DEVELOPMENT REVIEW COMMITTEE (DRC) COMMENT REPORT

PROJECT NAME: 333 Victoria

CASE NUMBER: R18071

REQUEST: Site Plan Level III Review: 63 Multifamily Residential Units with Parking Reduction in Downtown

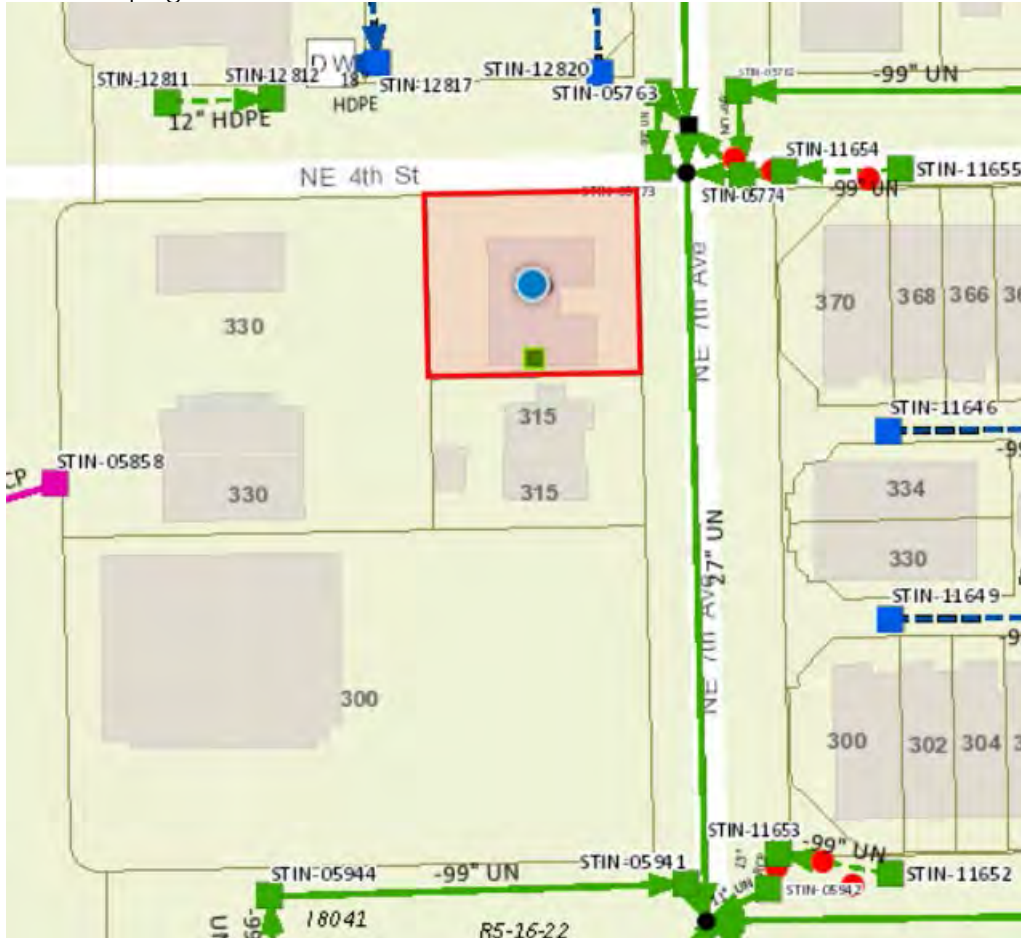
The City owns and maintains stormwater infrastructure adjacent to the proposed development as shown with green line work in the map provided at the end of this report. **Civil plans shall be revised to show the City's stormwater inlet ID #s as identified in the map provided at the end of this report.** The following comments pertain to possible impacts of the proposed development and/or construction activities to the existing condition of the City's stormwater assets. The applicant shall provide an itemized response letter addressing the following comments:

1. Please provide (or revise if already submitted) an erosion, sedimentation, and stormwater pollution prevention plan (**SWPPP**) showing the adjacent City's existing stormwater system as shown in the survey and to the limits shown with green line work in the storm map provided at the end of this report. A copy of the approved SWPP shall be at the construction site from the date of demolition initiation to the date of final construction activities.

- a) Contractor shall provide CCTV videotapes to City STW OPS of the existing stormwater system to the limits shown with green line work in the storm map provided at the end of this report in order to document the PRE and POST construction conditions of the City's storm system.
